MEMORANDUM

TO: Landmarks Board

SUBJECT: Continuation of a public hearing and consideration of an application for a Landmark Alteration Certificate to construct a 1,282 sq. ft. addition to the main house, to relocate an existing garage on the property, and to construct a 330 sq. ft. one-car garage at 711 Pine St. in the Mapleton Hill Historic District, per section 9-11-18 of the Boulder Revised Code 1981 (HIS2014-00172).

Figure 7. Proposed Site Plan. Not to scale.

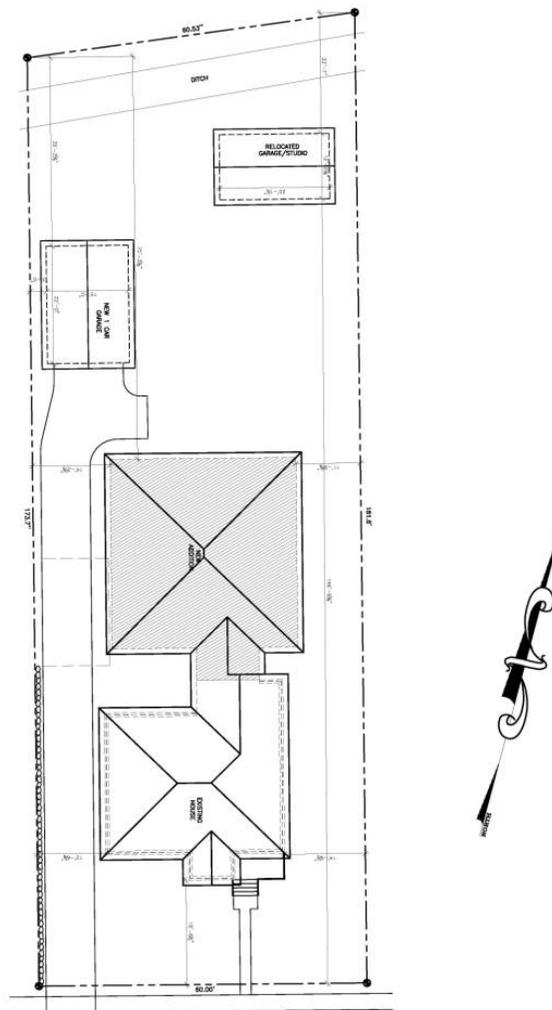
Plans show the revised one-story addition to feature low hipped roof that references the existing house and reduces visibility of the mass from the street. A portion of the addition will be visible to the east side of the existing house; however, it is set back approximately 50 feet from the street.

The addition is shown to be sided in narrow wood clapboard siding. Details on windows, doors, roofing and treatment of exterior materials on the existing house were not specified in the application.

2. Prior to submitting a building permit application and final issuance of the Landmark Alteration Certificate, the applicant shall provide details on the rehabilitation of the existing house including, but not limited to, removal of vinyl siding and shutters, as well as details on the move and rehabilitation of the existing garage.

3. Prior to submitting a building permit application and final issuance of the Landmark Alteration Certificate, the applicant shall submit the following, which shall be subject to the final review and approval of the Landmarks design review committee: window and door details, wall material details, siding material details, paint colors, roofing material details and details regarding any hardscaping on the property to ensure that the approval is consistent with the *General Design Guidelines* and the *Mapleton Hill Historic District Guidelines* and the intent of this approval.

Figure 22. Proposed new garage and relocated garage/studio.

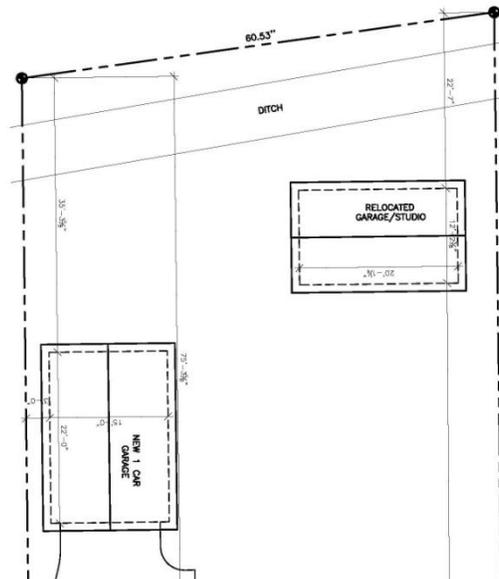
Plans call for the existing 245 sq. ft. garage to be relocated from the west side of the lot to the east side and to be used as a studio. The current proposal shows the garage turned at a 90 degree angle so the existing garage would face west. Other than relocation, no changes are shown to be made to the existing garage. A new one car garage of 330 sq. ft. is shown to be located behind the house by the west property line. Due to the slope of the lot, the simple gable end building is shown to be bermed into the ground at the north. Fenestration consists of a simple wood garage door at the south with a man door and single light casement window on the east face of the building. Plans call for the new building to be sheathed in wood clapboard siding to match the proposed addition.

1.	<i>The use of alleys to provide access to the rear of properties should be preserved.</i>	Access to garage appears to have been historically taken from Pine St. Garage will no longer take access from alley. Steps might be taken to provide grass wheel path from garage door to sidewalk. Resolve at Ldrc.	N/A

Figure 23. South and East Elevations of proposed garage.

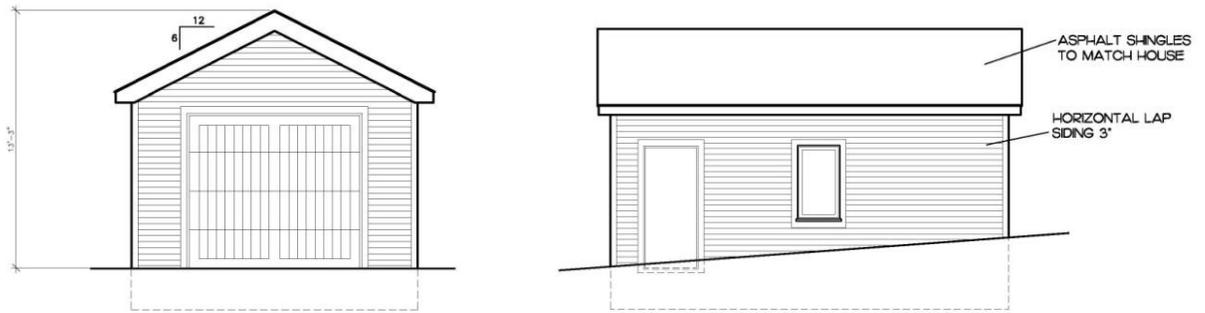
Mass and Scale			
.5	<i>New accessory buildings should take design cues from the primary building on the property, but be subordinate to it in terms of size and massing.</i>	Proposed design relates to existing house and garage; size and massing are appropriate.	Yes
.6	<i>New garages for single-family residences should generally be one story tall and shelter no more than two cars. In some cases, a two-car garage may be inappropriate.</i>	Proposed one-car garage is one-story tall. Massing proportionate to built mass and open space on property.	Yes
.7	<i>Roof form and pitch should be complementary to the primary structure.</i>	Roof form is complementary to the main house.	Yes
Materials and Detailing			
.8	<i>Accessory structures should be simpler in design and detail than the primary building.</i>	As shown, garage is simpler than main house in design, material, and detailing.	Yes
.9	<i>Materials for new garages and accessory structures should be compatible with those found on the primary structure and in the district. Vinyl siding and prefabricated structures are inappropriate.</i>	Proposed materials (wood siding, windows, and doors) will be compatible with character of historic district. Review details at Ldrc.	Maybe

.10	<i>Windows, like all elements of accessory structures, should be simpler in detailing and smaller in scale than similar elements on primary structures.</i>	Proposed design of windows on east and elevation appears to be compatible in terms of window type, size and detailing with similar elements on the primary building.	Yes
.12	<i>Garage doors should be consistent with the historic scale and materials of traditional accessory structures. Wood is the most appropriate material and two smaller doors may be more appropriate than one large door.</i>	Garage doors appear to be consistent in terms of scale and materials. Review final details at Ldrc.	Maybe
.13	<i>It is inappropriate to introduce features or details to a garage or an accessory building in an attempt to create a false historical appearance.</i>	Proposed design does not attempt to recreate a false historic appearance.	Yes
